Proposal for Supplement 3 to the Original Version of UN Regulation No. 158 (Devices for means of rear visibility or detection)

The text reproduced below was prepared by the expert from the Republic of Korea. The modifications to the current text of UN Regulation No. 158 are displayed in bold for new or strikethrough for deleted characters.

Figure 1. example for cargo truck tail gate.

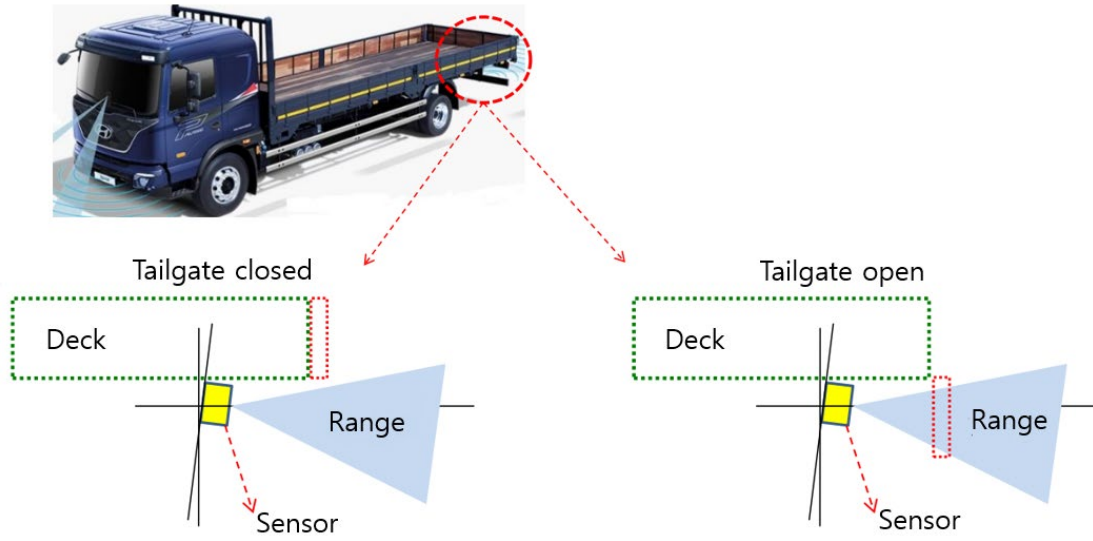
2. In addition, the test conditions should specify that not only rear hatches or trunk lids but also the tail gates of cargo trucks and van-type vehicles should be closed or latched in their normal vehicle operating condition during the test. For additional information on this matter, please refer to the following figures.

"1.3.3.4. Rear hatch ~~and~~, trunk lids: **and tail gates**.

If the vehicle is equipped with rear hatches, ~~or~~ trunk lids; **or tail gates**, they are closed and latched in their normal vehicle operating condition."
